**FAQ Number** 07-0038 Revision 2

**FAQ Title** Lessons learned on Multiple Spurious Operations

Plant: Turkey Point

Date: June 30, 2010

**Figure XX – Multiple Spurious Operations – Transition Resolution Process**

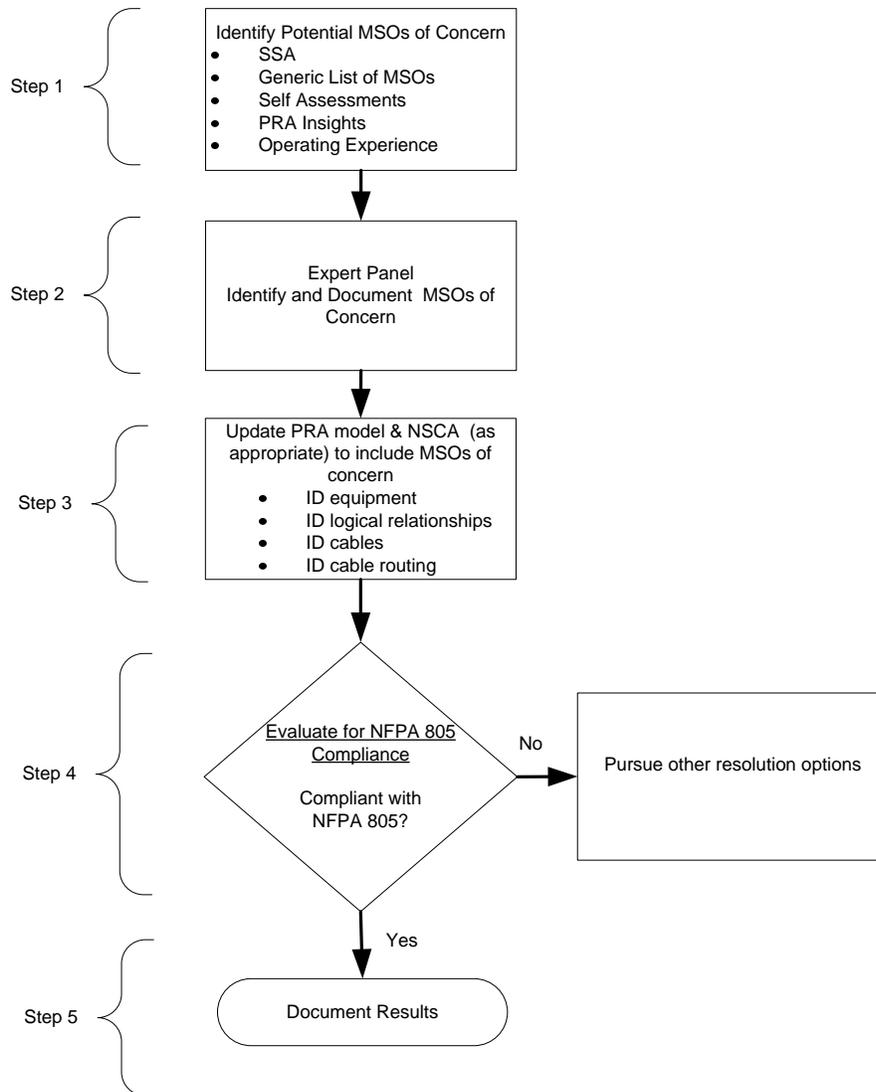
Add the following section to Appendix B of NEI 04-02 Revision 2

### **B.2.1.3 Fire-Induced Circuit Failures (Multiple Spurious Operations)**

The approach outlined in Figure XX below is one acceptable method to address fire-induced MSOs. This method uses insights from a Fire PRA that meets the requirements of Regulatory Guide 1.205, Revision 1.

### **Step 1 - Identify potential MSOs of concern.**

### **Step 2 - Conduct an expert panel to assess plant specific vulnerabilities (e.g., per NEI 00-01, Rev. 1 Section F.4.2).**

### **Step 3 – Update the Fire PRA model and NSCA to include the MSOs of concern.**

### **Step 4 – Evaluate for NFPA 805 Compliance**

### **Step 5 - Document Results**
